Southern California Edison Company

March 30, 1984

Subject: Docket No. 50-206
Systematic Evaluation Program Integrated Assessment
San Onofre Nuclear Generating Station
Unit 1

Fig. 1 Critical Buckling Pattern for Songs-1 Containment

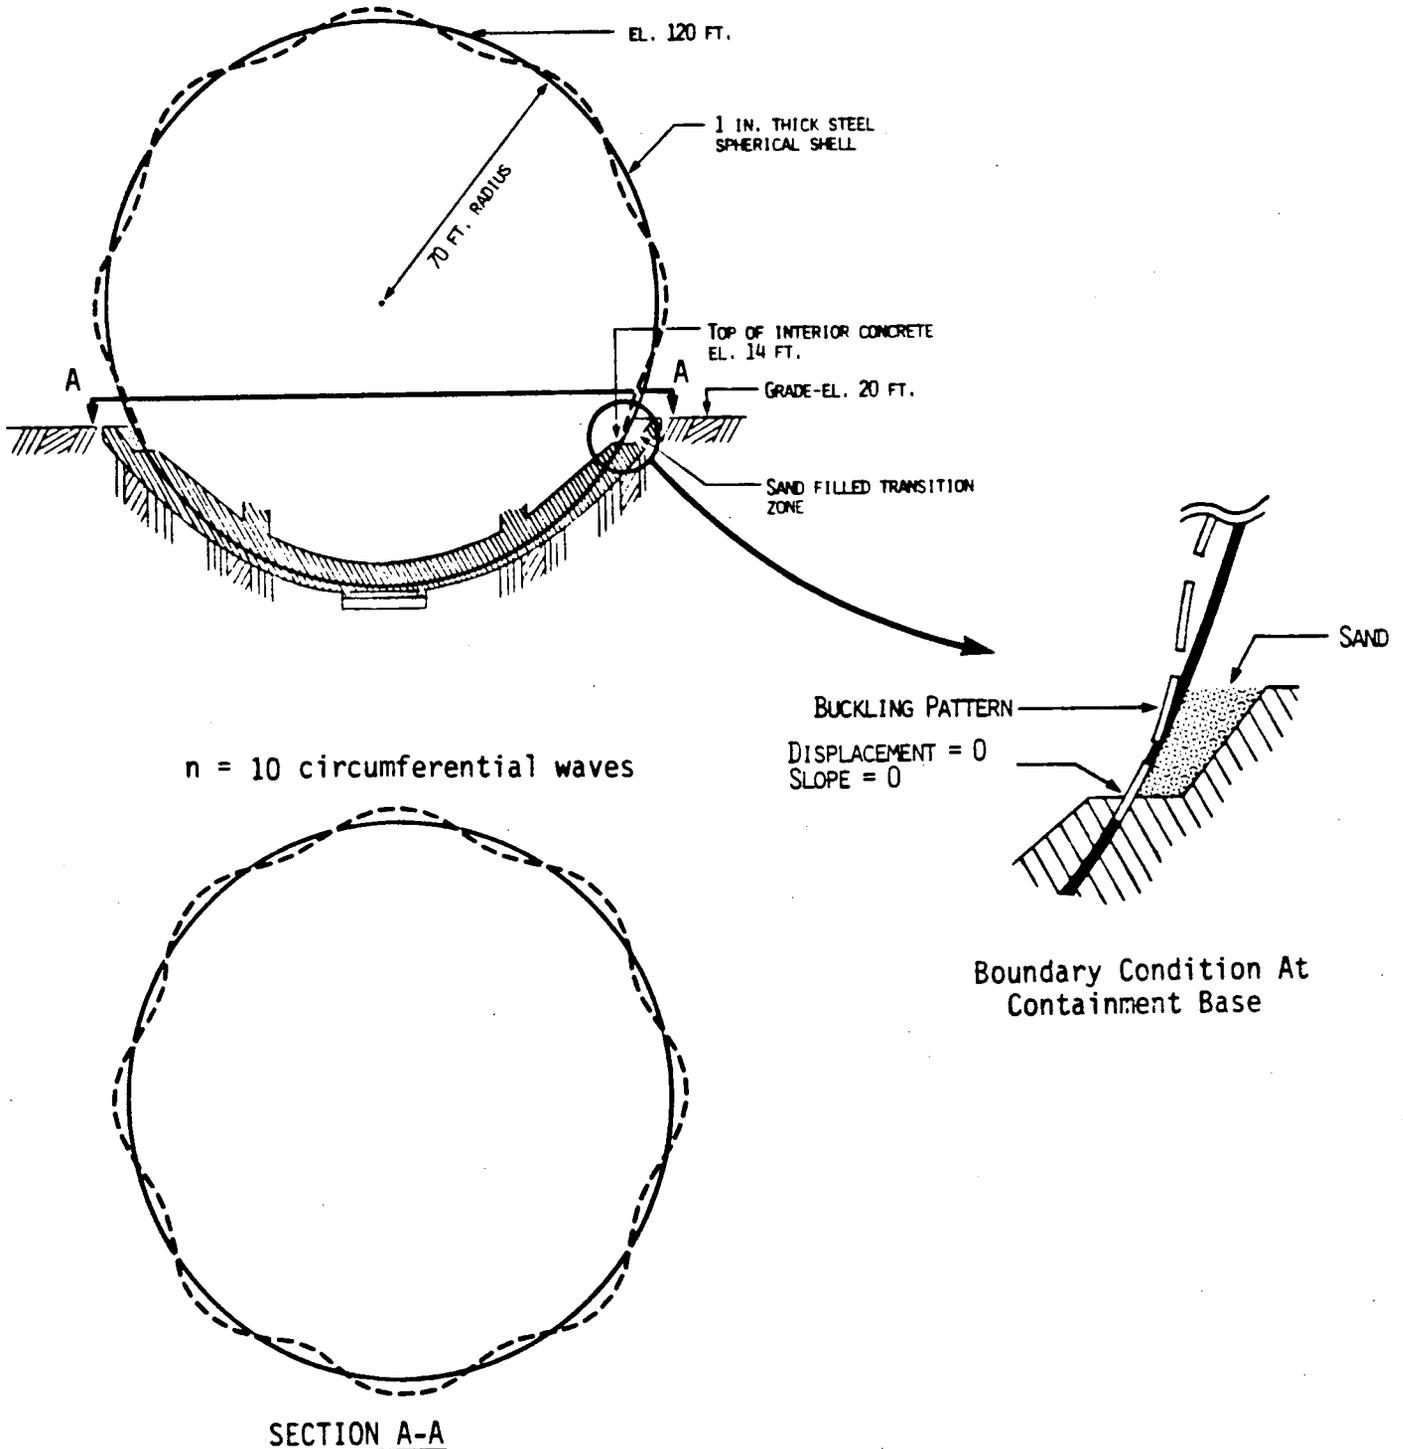
Additionally, the fixed boundary condition at the concrete further limits the expected buckling pattern (see Figure 1). Since the shell has zero slope at the concrete, there must be greater distance away from the fixity for the buckling pattern to develop. Therefore, the effective zone over which a half wavelength of buckling can occur is even smaller and the corresponding buckling pattern requires even more waves and higher critical stresses.

In summary, to develop a buckled pattern within the short meridional distance over which the compression acts requires a buckling stress much higher than the critical buckling stress. Therefore, this compressive zone is "local" with respect to the expected buckling pattern and it is overconservative to use these stresses for design against Code buckling limits. An alternative approach considering the average compression over an area large enough to allow buckling gives a design stress close to zero and within Code limits.

Fig. 2 Stabilizing Effect of Sand-Transition Zone

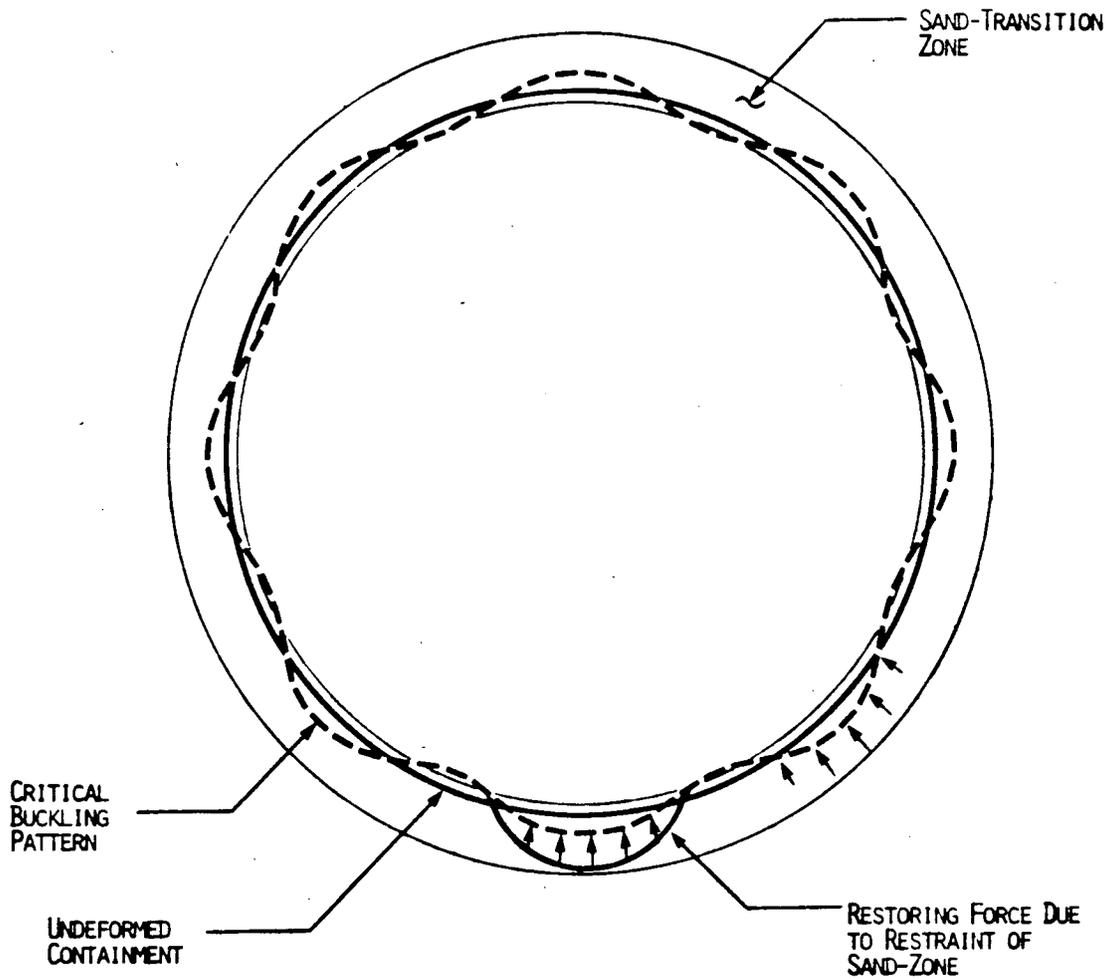
The high compressive stresses predicted by the LLNL study result from the effectiveness of the sand transition zone in restraining shell thermal growth. Given the nearly constant level of compression throughout the zone, the effect of the sand is to move the effective point of fixity of the containment boundary conditions to just below grade level. In essence, the sand transition zone acts as a ring stiffener for the sphere and therefore increases its capacity against buckling near the base.

The sand zone does not act as a fully welded stiffener in that the shell is free to draw inward away from the sand. However, the above discussion on buckling patterns indicates that the critical buckling pattern will require several waves in the circumferential direction. Therefore, portions of the shell will need to deform outward to conform to this pattern (see Figure 2). The sand stiffness is adequate to resist this motion (as evidenced by the high thermal stresses created by this resistance) and it is unlikely that the sand will conform to the buckling pattern. A buckling pattern where the shell draws in uniformly around its circumference is not expected under circumferential compression and is more typical of buckling behavior under an axial compressive load.

Therefore, the sand transition zone is expected to provide adequate stiffening against buckling and will help stabilize the shell. Reference 15, for example, discusses the formation of buckling patterns and the significance of restoring forces in inhibiting the

FIGURE NO. 1

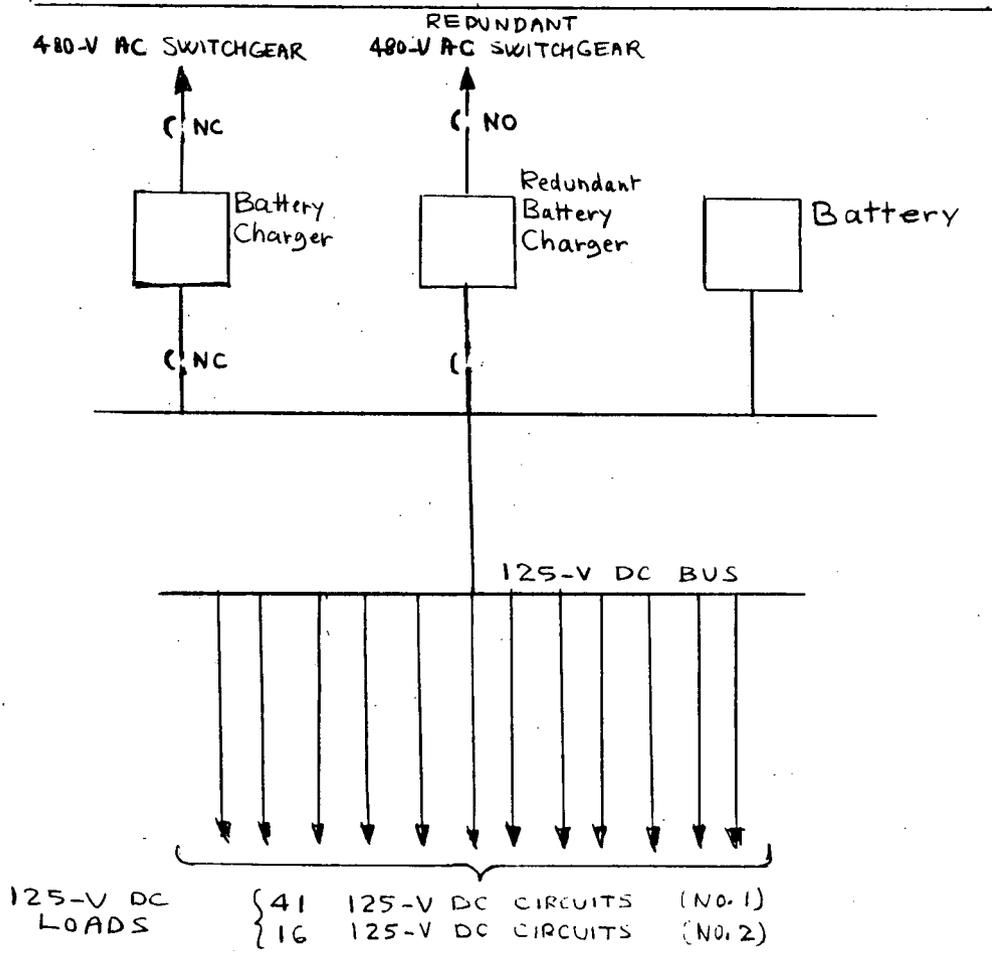
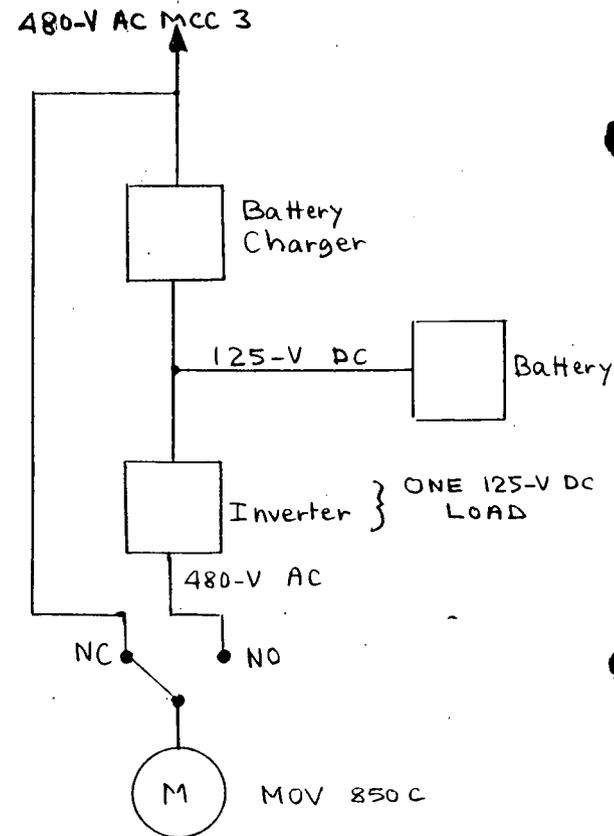
1. As shown by Figure No. 1, the UPS system is needed only during SISLOP (extremely unlikely) and during testing of the safety injection system (SISLOP tests) once every 18 months. Except on these rare occasions, the only DC current existing in the UPS system is the no-load current of the inverter and the minimum charging current on the battery to maintain its charge, as shown by Figure No. 1.

2. The exposure of the UPS system to ground faults is very limited when compared to the 125-V DC systems Nos. 1 and 2. As shown by Figure No. 1, instead of serving a multiplicity of loads with DC cables routed throughout the plant, it serves only one load: the inverter that provides 480-V AC power to MOV 850C. The inverter and the battery charger are enclosed in adjacent cubicles close to the battery location.

3. If a ground fault occurs and develops into a ground fault on both positive and negative leads, the battery will discharge which will result in a low voltage and will cause a low voltage alarm in the Control Room. Because a SISLOP is extremely unlikely, enough time would be required to correct the problem. Even if SISLOP occurs, Safety Injection can still take place with only one Safety Injection Valve. If MOV 850C fails, safety injection valves MOV 850A and MOV 850B would be available.
